SERVICE BULLETIN M20-289A

Date: August 01, 2005

SUBJECT: AILERON CENTER LINK CLEARANCE

Figure SB M20-289-1

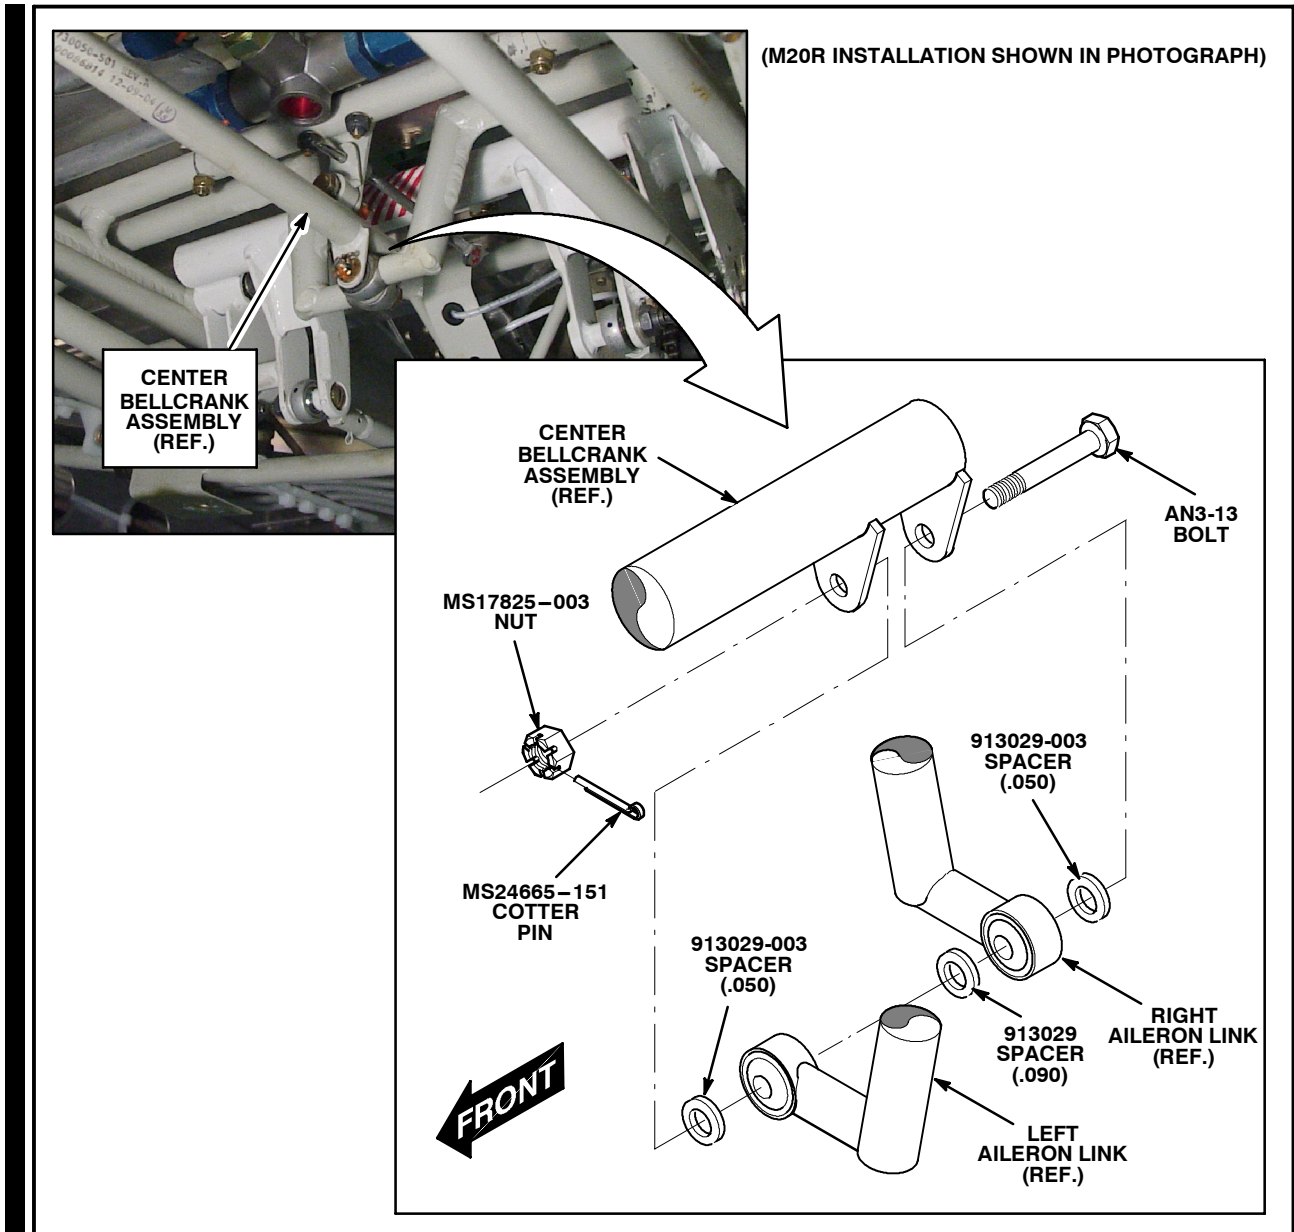
INTRODUCTION: To prevent Left and Right Aileron Links from rubbing on Gear Retraction Bellcrank with gear extended.

1. Turn master switch - OFF
2. Per instructions provided in Section 53 of applicable aircraft Service and Maintenance Manual, remove Belly Skin for access to Center Bellcrank Assembly.
3. Locate Center Bellcrank Assembly and remove attaching hardware securing Left and Right Aileron Links (ref. Figure M20-289-1).

4. Discard existing AN3-13 Bolt, 913029 Spacer, MS17825-003 Nut and MS24665-151 Cotter Pin.
5. Reassemble Left and Right Aileron Links to Center Bellcrank Assembly with hardware from kit M20-289-000. Follow order of hardware assembly as follows (ref. Figure M20-289-1):

913029-003 Spacer (Install between aft lug on Center Bellcrank and Right Aileron Link)

913029 Spacer (Install between Right Aileron and Left Aileron Links)

913029-003 Spacer (Install between Left Aileron Link and forward lug on Center Bellcrank)
